BRENT SPENCE BRIDGE REPLACEMENT STUDY
Revised Signing for Concept I-W 3-23-2022
CONCEPT I-W
CONCEPTUAL SIGNING PLAN
SCALE
0 300 600
LEGEND
MAINLINE SIGNS
C-D ROAD SIGNS
Pink SB signing changes
Lt Blue NB signing changes
Red New signs
Black X Sign not needed
HNTB Review 5-25-2022

BRENT SPENCE BRIDGE HIGHWAY SIGNING REVIEW FOR CONCEPT I-W

PURPOSE: The purpose of this document is to address comments from ODOT and KYTC dated July 6, 2022 in response to the latest review of the potential highway signing plan for Concept I-W. The goal of the signing review is to determine, at a conceptual level, if there are any fatal flaws in the conceptual signing plan in transitioning from Alternative I to Concept I-W and to reflect the changes (if any) required on the Alternative I signage plan to accommodate Concept I-W.

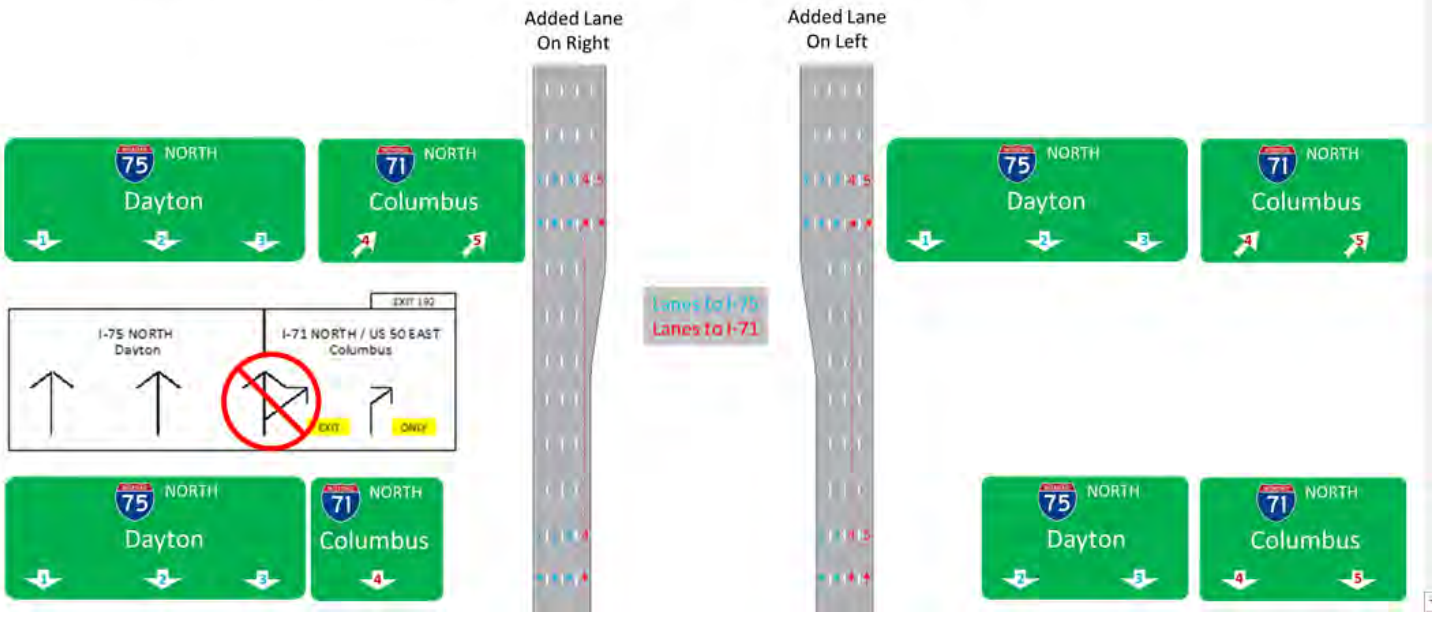
However, regarding the NB lane situation, I maintain that the use of upward facing Arrow-per-Lane signage with an option arrow is not applicable in the area just north of Kyle's Ln. Ignoring the two right lanes that drop at Exit 190, we have 4 "through" lanes at this point. Those 4 lanes become 5 lanes, but its by adding a lane on the far right. So the 3rd lane from the left doesn't change at all – if you stay in that lane, you WILL go through to I-75. It is not an option lane. You have to be in the 4th lane from the left to access I-71. By being in the 4th lane you can then also get in the 5th lane once it opens up, and either of those two lanes will take you to I-71 – but not the 3rd lane.

If there is concern about directing all of the I-71 traffic into a single lane (before the 5th lane gets added), you could change the striping so that the added lane comes in on the left. That would make it to where when you have 4 lanes, it would be 2 lanes for each movement, then the 5th lane (added on the left) would make 3 lanes for I-75.

But in neither situation should you use APL signing with an option lane because there is no option lane.

Here is a graphic I put together of both scenarios, depicting the lanes and associated signing to show how Lane 3 never goes to I-71.

The KYTC comments point out that the creation of the fifth lane northbound in Kentucky could be an add-lane on either side of the highway. This will require further design to determine the best fit. There may also be a need for verification of lane use/signing with traffic analysis and modeling to determine how best to position the NB I-75 and I-71 traffic in the four lane section (as a 3 and 1 or 2 and 2 configuration) and how far in advance of the add-lane that the mainline movements should be signed separately. These issues can be addressed as part of the next phase of design.
